UNITED STATES
NUCLEAR REGULATORY COMMISSION
WASHINGTON, D. C. 20555

SAFETY EVALUATION BY THE OFFICE OF NUCLEAR REACTOR REGULATION

NINE MILE POINT NUCLEAR STATION, UNIT 1

CONTROL ROD DRIVE PENTRATION LEAKAGE FROM STUB TUBE CRACKING

FIGURE 1

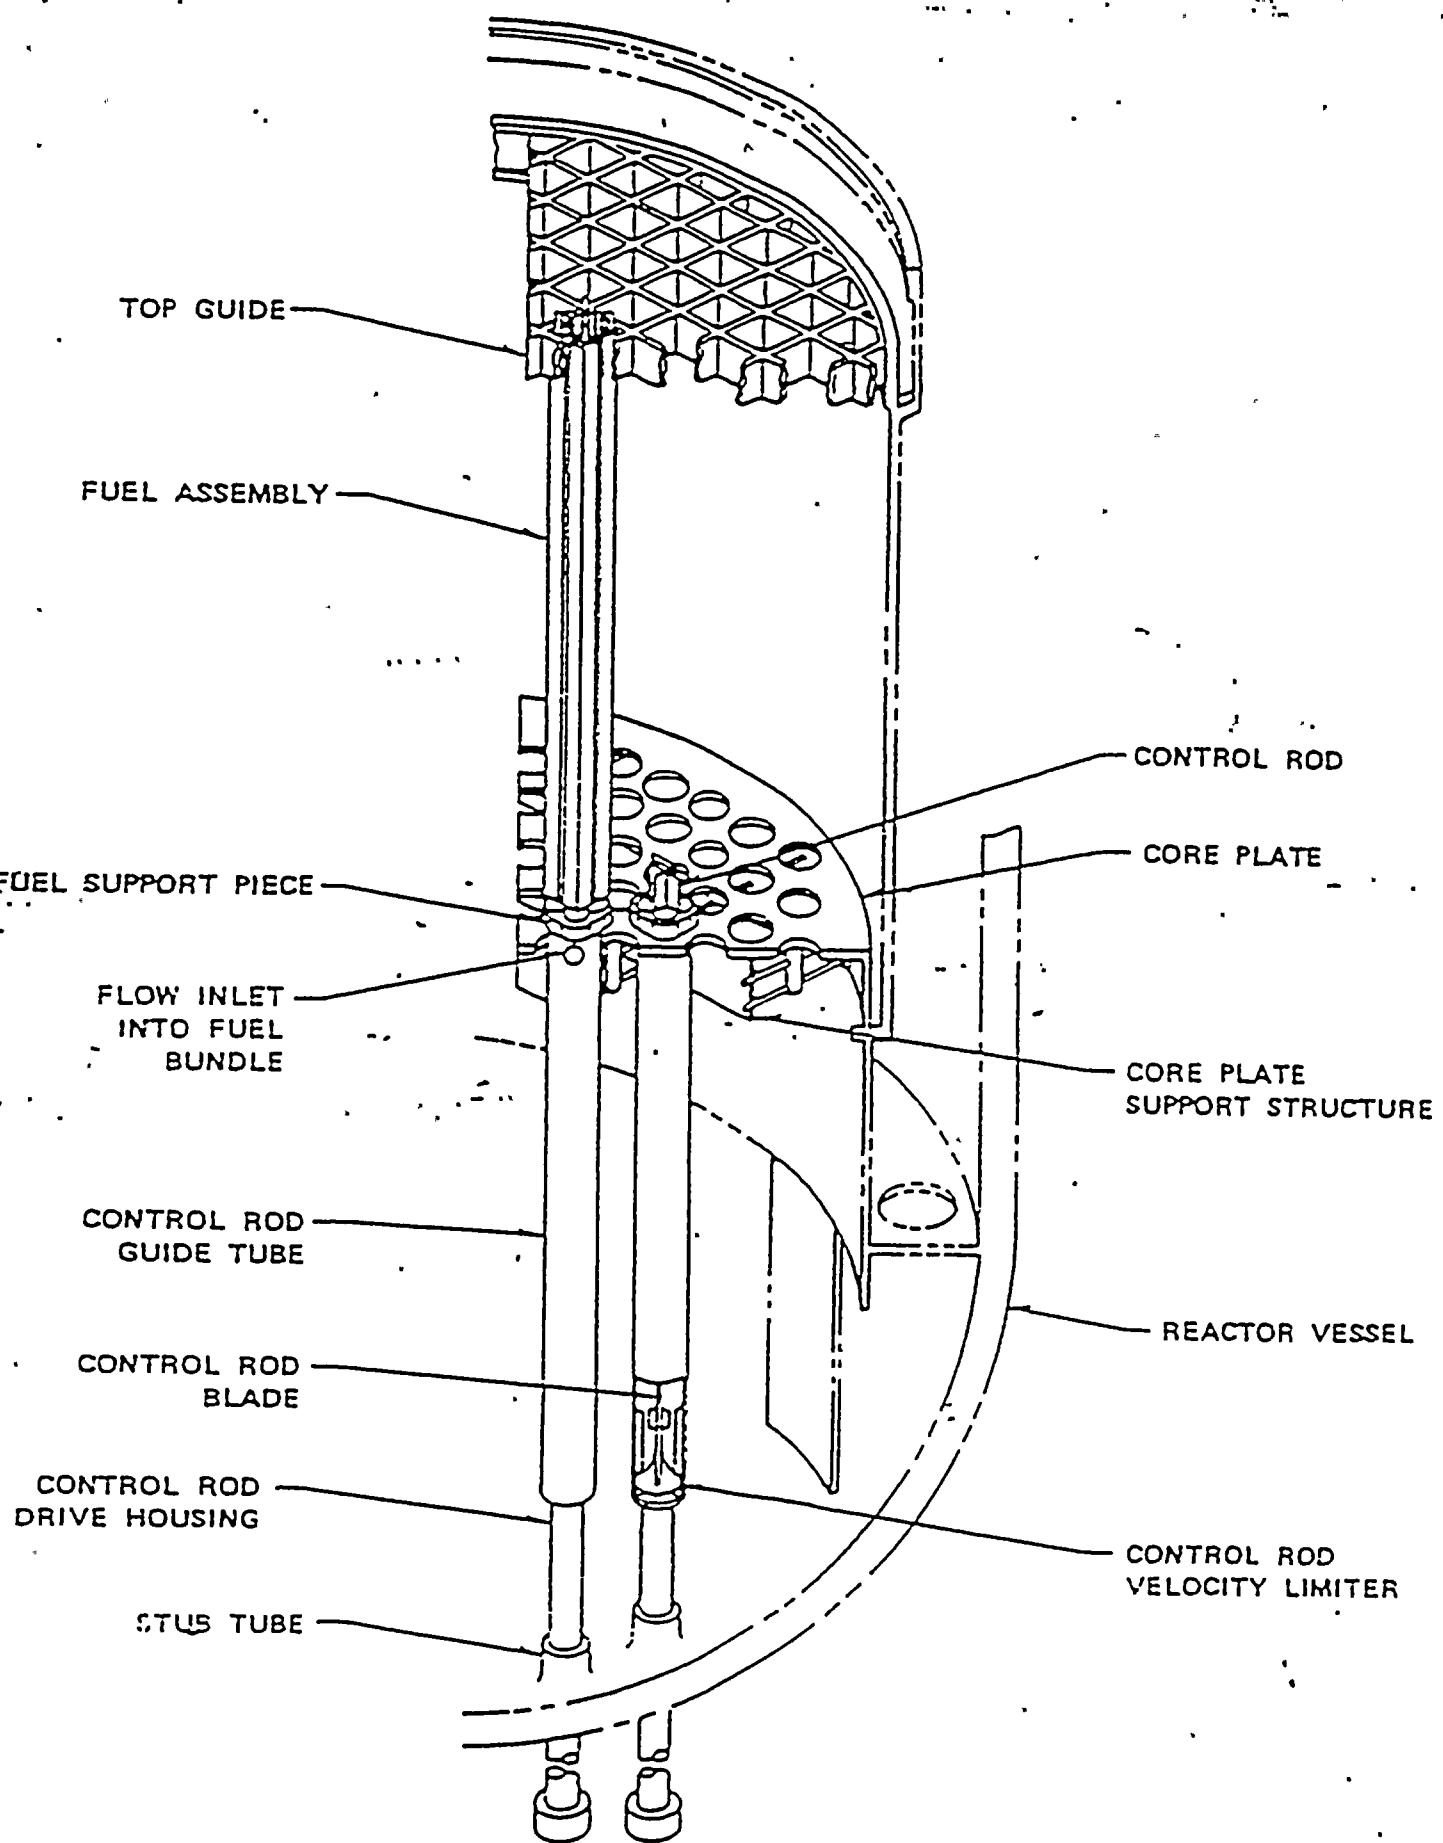
On March 27, 1984, during a refueling outage, an inspection was performed in the control rod drive (CRD) housings (Figure 1); at location 46-27, a small leak (see Figure 2) (approximately 15 drops per minute) was observed at the CRD housing flange. At location 14-11, water bead marks were observed at the top of the CRD housing flange. Additionally, there was either slight corrosion or film on the CRD housing at locations 30-07, 38-31, 42-39, 10-27 and 46-39. Because of these observations, additional examinations, visual (TV) and ultrasonic were scheduled. The visual (TV) examinations were performed on the stub tubes from the exterior of those tubes within the vessel and cracks were observed (see Table). The ultrasonic (UT) examinations were performed from the inside diameter of the control rod drive housing tubes both before and after the rolling repair. In neither UT examination were any reportable indications observed.
